Well Name: CANYON	Well Location: T25N / R11W / SEC 3 / SWSE / 36.424881 / -107.988083	County or Parish/State: SAN JUAN / NM
Well Number: 5	Type of Well: CONVENTIONAL GAS WELL	Allottee or Tribe Name: EASTERN NAVAJO
Lease Number: N00C14203597	Unit or CA Name: CANYON E/2, MANCOS - E2	Unit or CA Number: NMNM112647, NMNM75913
US Well Number: 3004521315	Operator: HILCORP ENERGY COMPANY

Notice of Intent

HILCORP ENERGY COMPANY
CANYON 5
P&A NOI

BLM - FFO - Geologic Report

CANYON 5 - PROPOSED WELLBORE SCHEMATIC

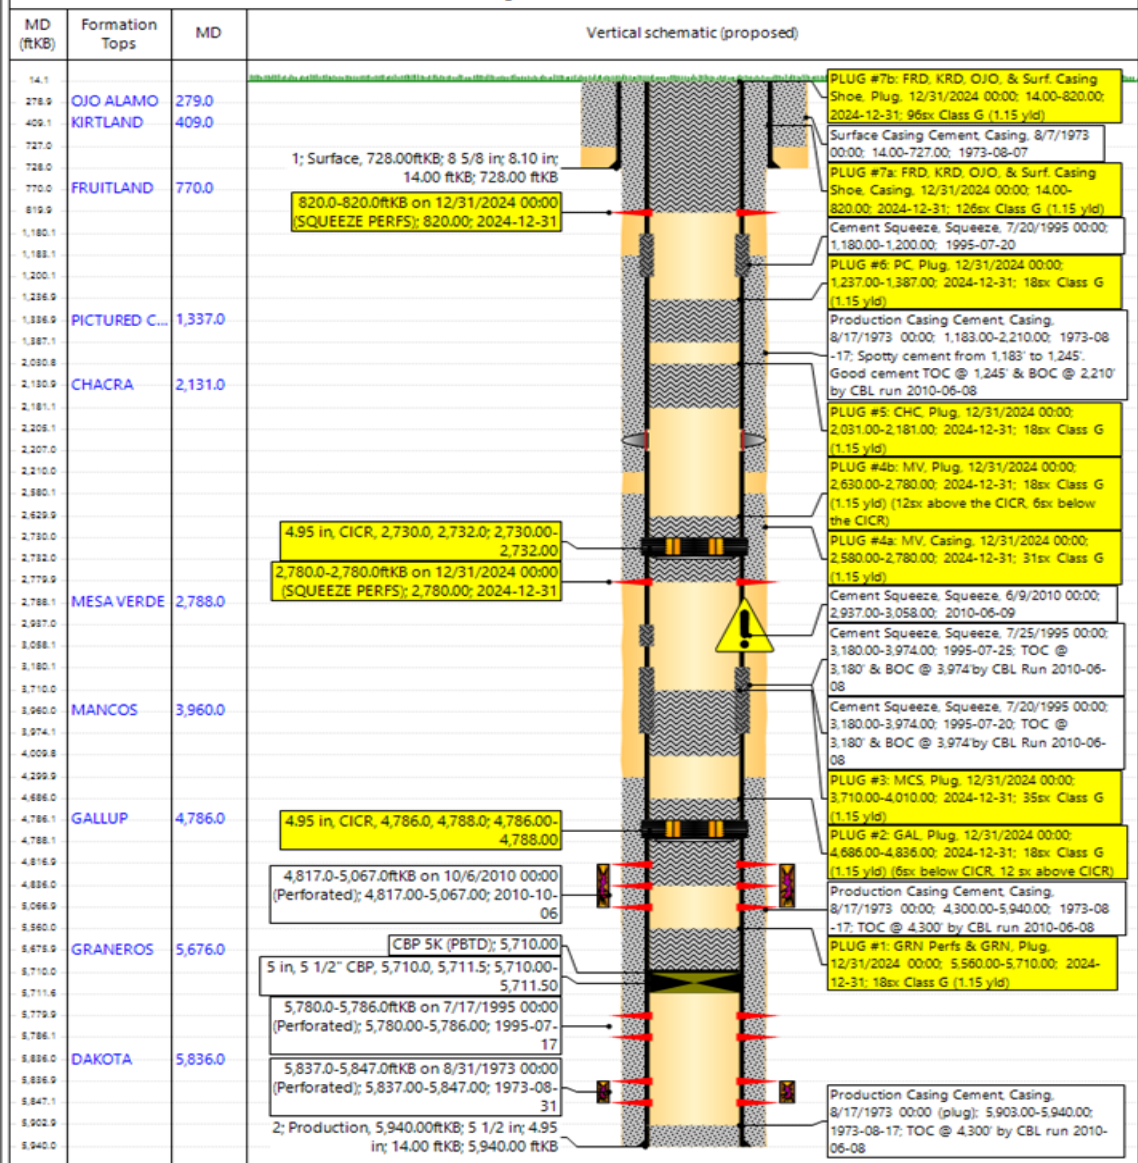
The available induction log and the reference well indicates that the top of Chacra and the Mesa Verde Group are in different locations compared to the locations provided by the operator. Add a plug to cover the BLM selected Chacra top location at 1690 ft. Do not change locations of plug 4 and plug 5 as designed. The two plugs will properly cover the Mesa Verde group including the top selected by the BLM at 2131 ft.

Created By	Condition	Condition Date
mkuehling	Notify NMOCD 24 hours prior to moving on - monitor string pressures daily report on subsequent - Submit all logs prior to subsequent -Plug 1 will need to cover Dakota at 5836 Verified logs - NMOCD concurs with BLM on formation tops	5/23/2024

1. Plugging operations authorized are subject to the attached "General Requirements for Permanent Abandonment of Wells on Federal and Indian Lease."
2. The following modifications to your plugging program are to be made:
 - a. Add a plug to cover the BLM selected Chacra top location at 1690 ft.
 - b. Do not change locations of plug 4 and plug 5 as designed. The two plugs will properly cover the Mesa Verde group including the top selected by the BLM at 2131 ft.
3. Farmington Office is to be notified at least 24 hours before the plugging operations commence at (505) 564-7750.
